Appendix A

West Sound Cycle Club Presentation, March 2021

Overcoming obstacles to a wide, safe, shared use path across the Warren Avenue Bridge

Existing Warren Avenue Bridge Cross Section

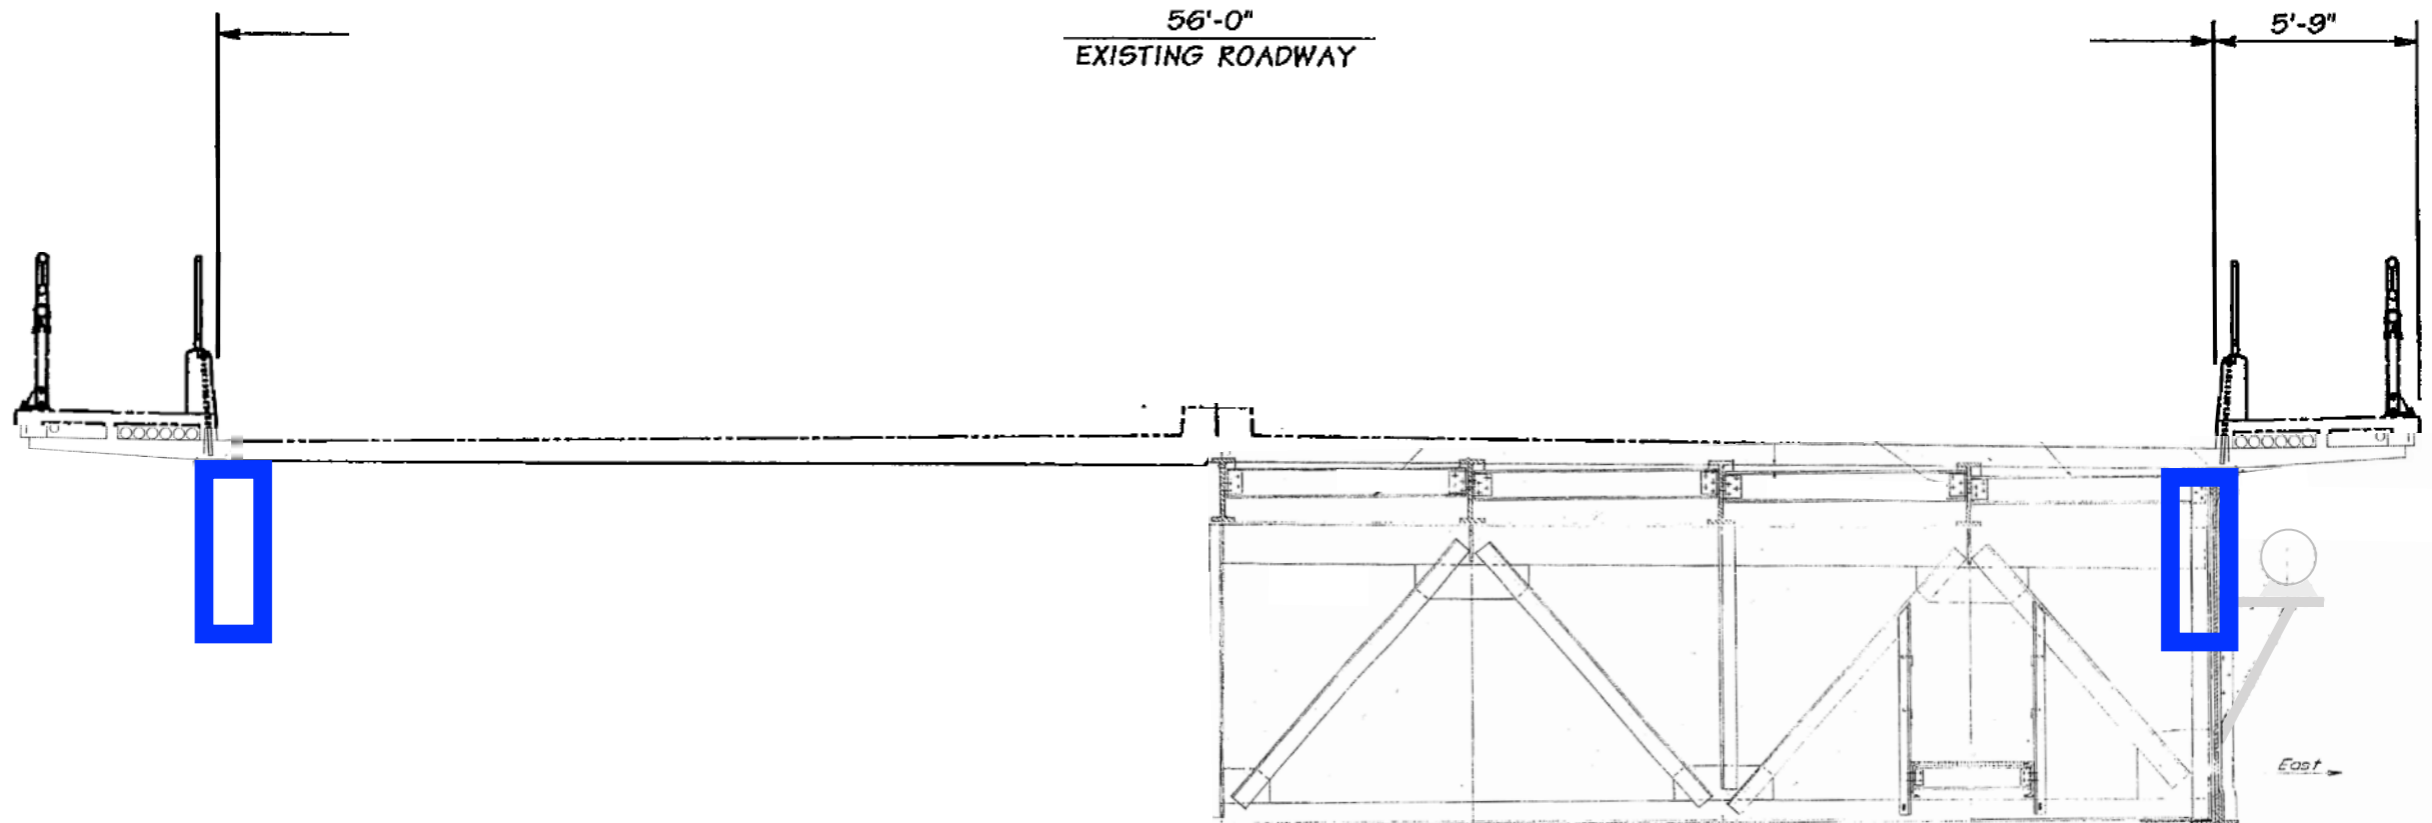
On March 16th, during the monthly Public Works Committee meeting we learned that Bremerton plans ***to narrow these paths to 8-feet***. The professed rationale for doing so is the inability of WSDOT's bridge inspection truck to reach over a 10-foot wide path to inspect the underside of the mid-bridge steel supports. Since WSDOT's current inspection truck can reach over an 8-foot path, WSDOT recommends substituting an "8-foot sidewalk" for the shared use path. The term "sidewalk" is used presumably because a path of 8-feet no longer qualifies as a shared use path.

An 8-foot path is unacceptable for many of us. Bikes and pedestrians don't mix well in such a constricted space. The implication is that cyclists may be relegated to the roadway. It should be pointed out that there isn't room for a 5 or 6 foot bike lane on the bridge deck - a minimum requirement in this location. Motorists would approach cyclists from behind at several times their speed, separated from them by a painted line.

WSDOT's problem with bridge inspection can be solved by adopting WSCC's proposal to widen only the west side of the bridge. Their current inspection truck can extend its bucket 60 feet under the bridge - just shy of the full width of the bridge. Newer inspection trucks can extend their inspection bucket 75 feet, allowing inspection of the entire under-structure *from the east side of the bridge*. This approach (no construction on the east side of the bridge) will probably save 2 million dollars, enough to buy a 75 foot-capable inspection truck if needed.

Flight Diagram

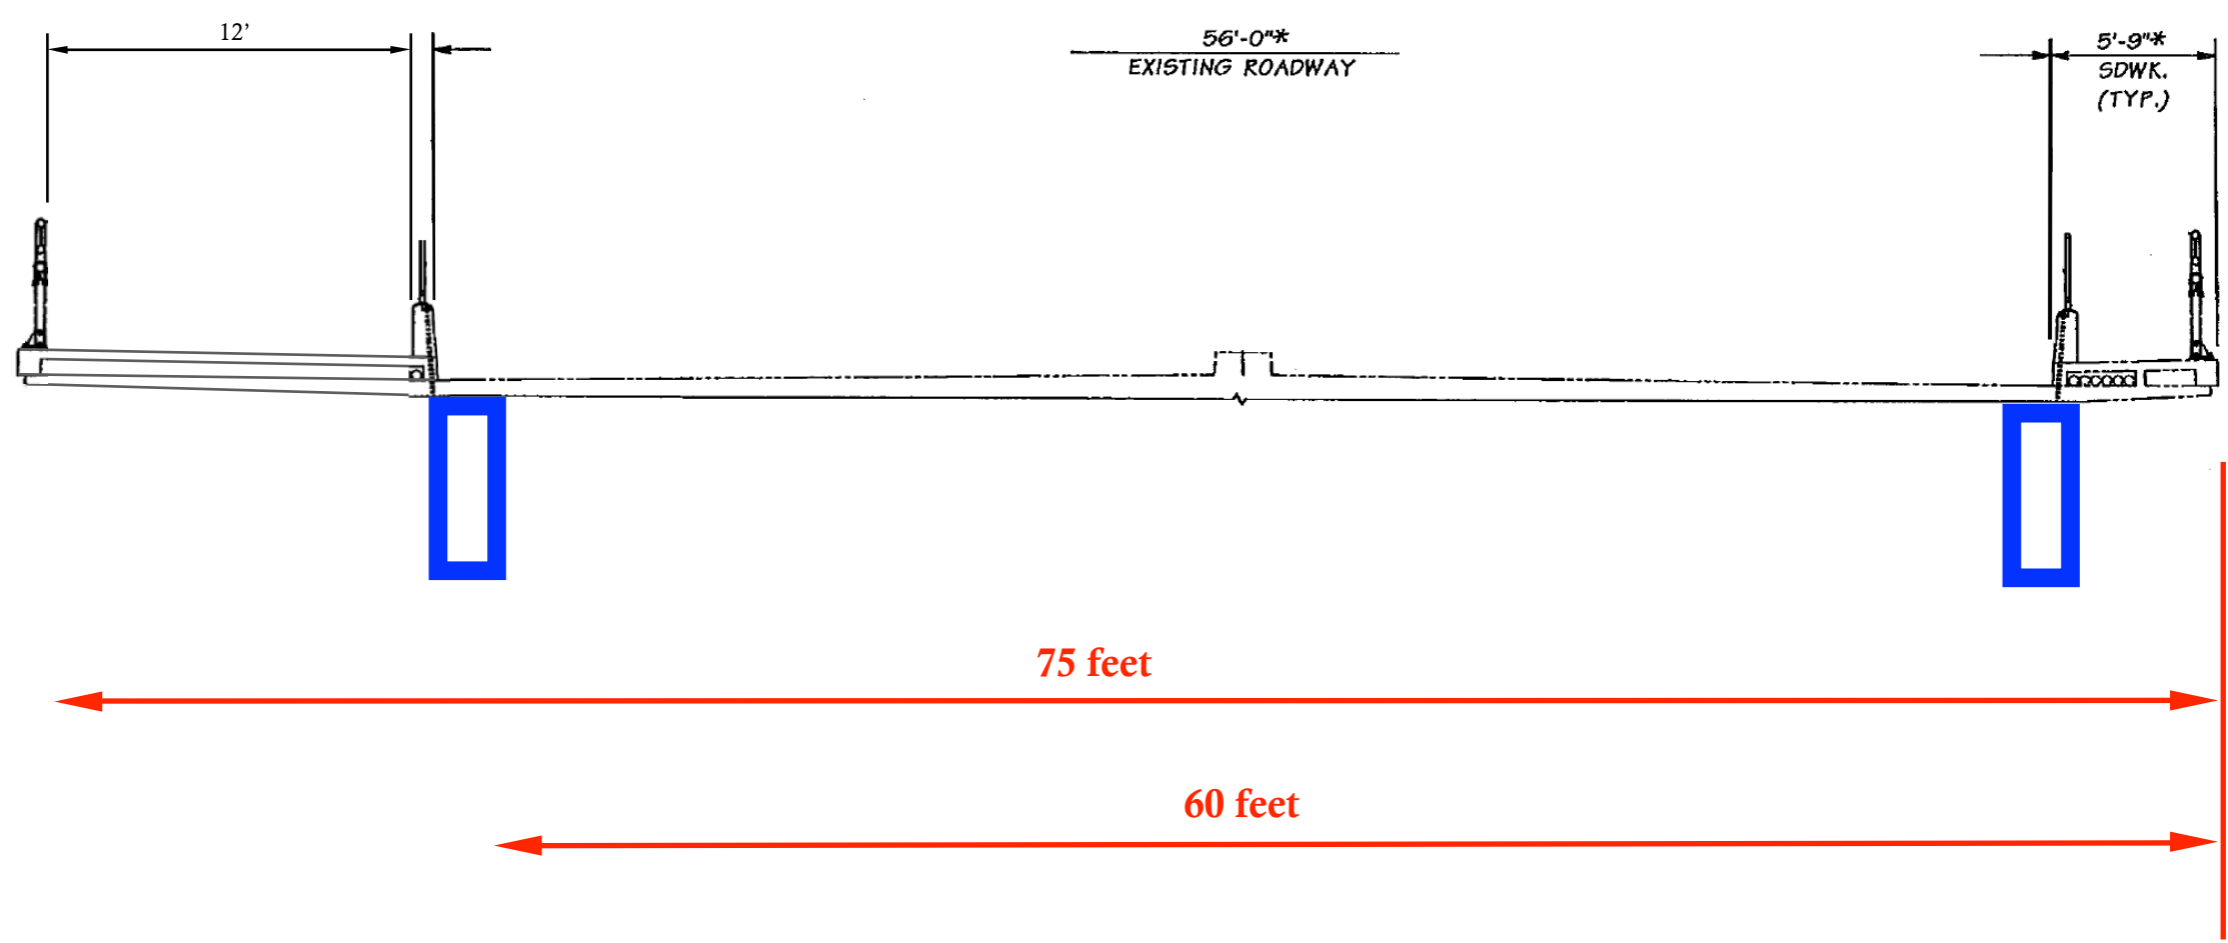
A brief internet search found this truck capable of inspecting the entire bridge infrastructure from one side of the bridge deck.
